# KENWOOD

ASI-0109

**Subject:** TS-890S MARS Modification

**Date:** November 8, 2018

Figure 1

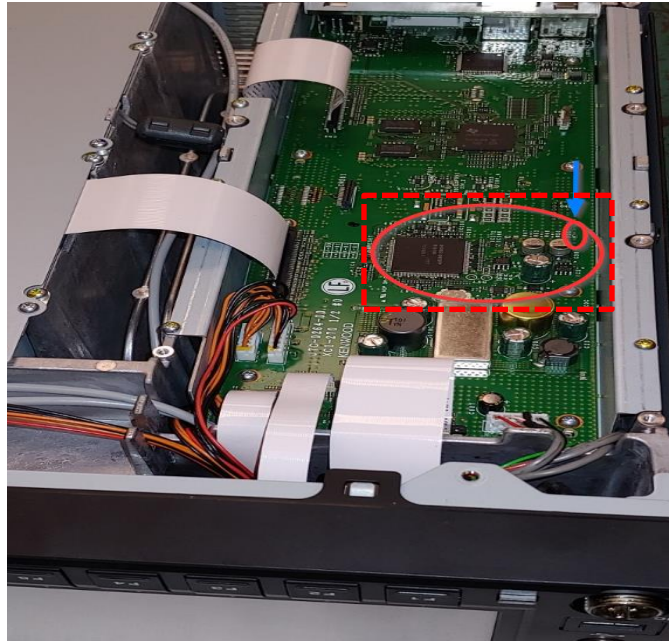
7. Locate R55 on the control unit (see figures 1 & 2).
8. Using surface mount soldering techniques and soldering tools, carefully remove R55. You may want to use two soldering irons or one soldering tweezer tip to heat the solder on both sides of R55 at the same time to lift it up. Be careful that you do not tear the foil traces. Also be careful to not burnp, pull, or rip any ribbon cables as you work to remove the resistor.

Figure 2

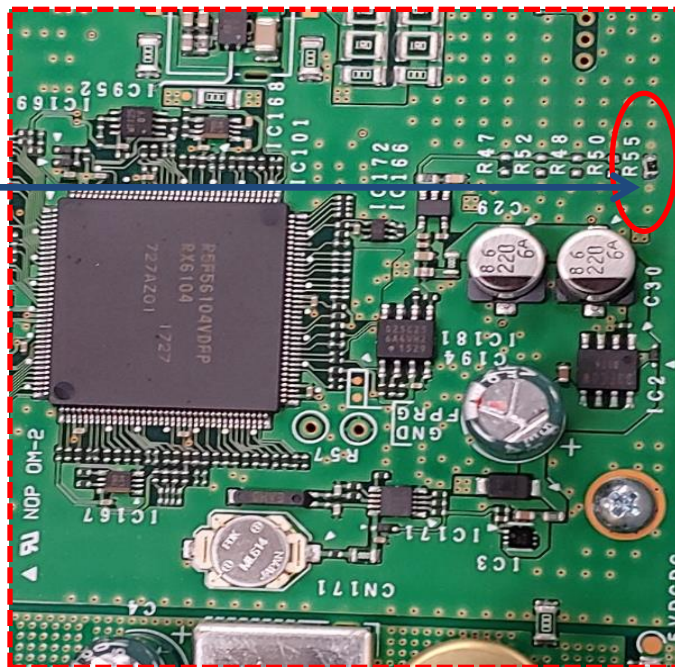
Remove  
R55
